RE: The Pilot School, Application No. 2008-0419-S
Preliminary Major Land Development Plan

Enclosed please find The Pilot School Preliminary Major Land Development Plan, \$500 review fee, and supporting documentation. The Preliminary Plan attempts to address many of the Department's concerns noted in the Exploratory Plan Report dated September 22nd, 2008. Our responses to the report are ordered according to the Department's report and can be found below:

Figure 5-4 Design Alternatives in lieu of Cul-de-Sacs in Reduced Right-of-Way
(Not to Scale)

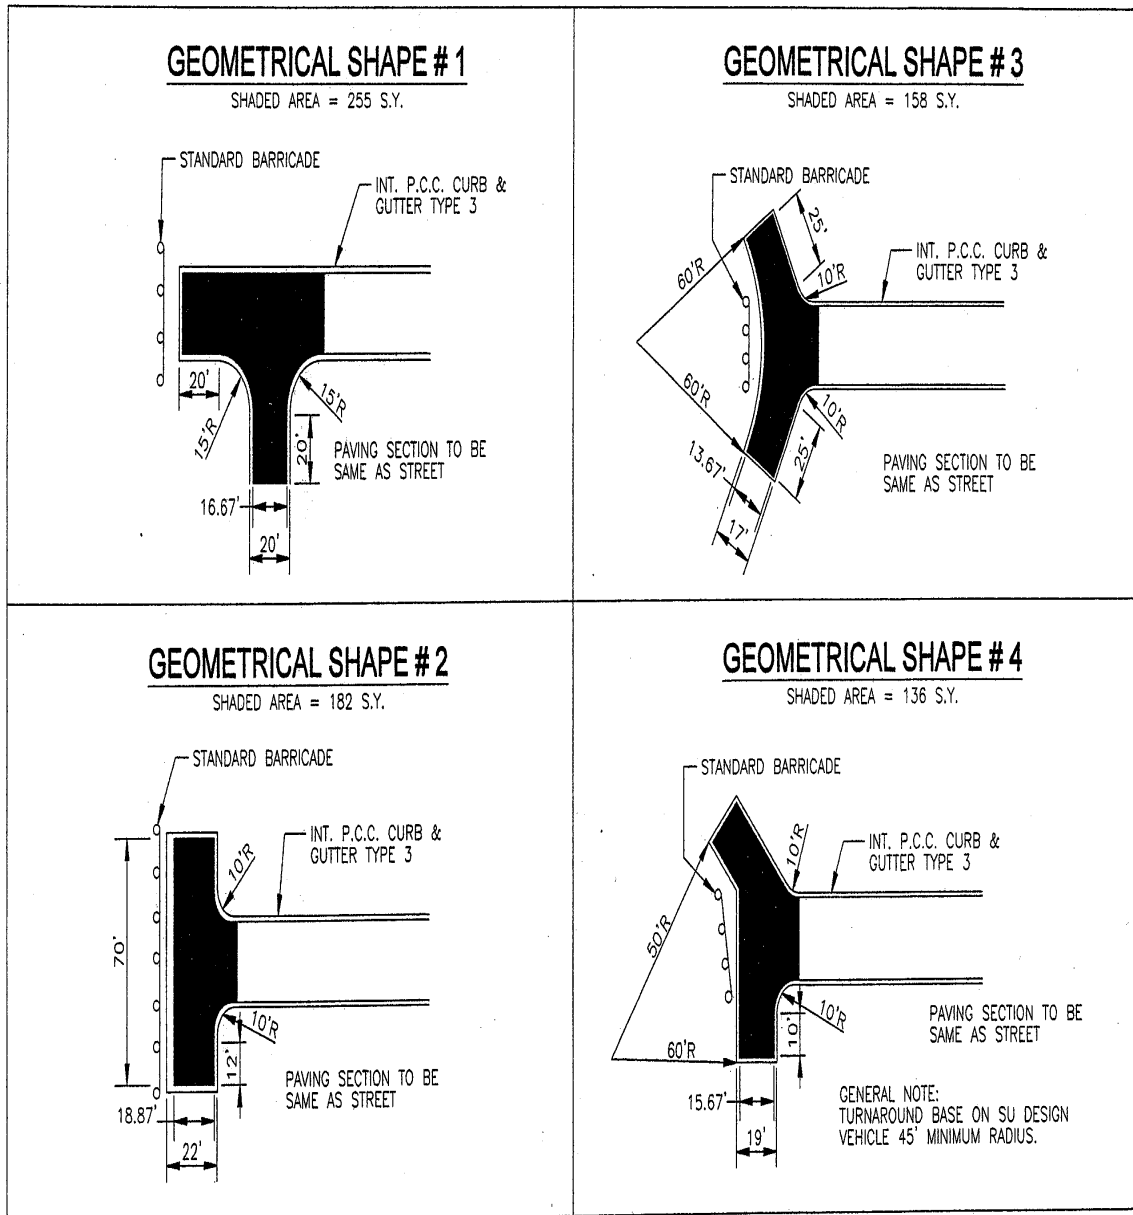
7. A DeDOT and Office of State Fire Marshal compliant turnaround is provided and the width is sufficient to serve two way traffic and serve as a secondary fire lane. A loop road around the building was deemed impracticable due to the steep slopes and the fact that the proposed design satisfies the requirements for perimeter access by emergency vehicles; We ask that you re-consider the request for a waiver to provide dead end parking on the south side of the proposed school in consideration of the considerable area a turnaround would consume. The school could sign the areas as a no parking zone. A copy of Figure 5-4 from the DeDOT Standards and Regulations for Subdivision Streets and State Highway Access is attached. Please note that the indicated widths on this exhibit are to the outside of the curb. The design shown on the site plan combines geometric shape #1 and #3.
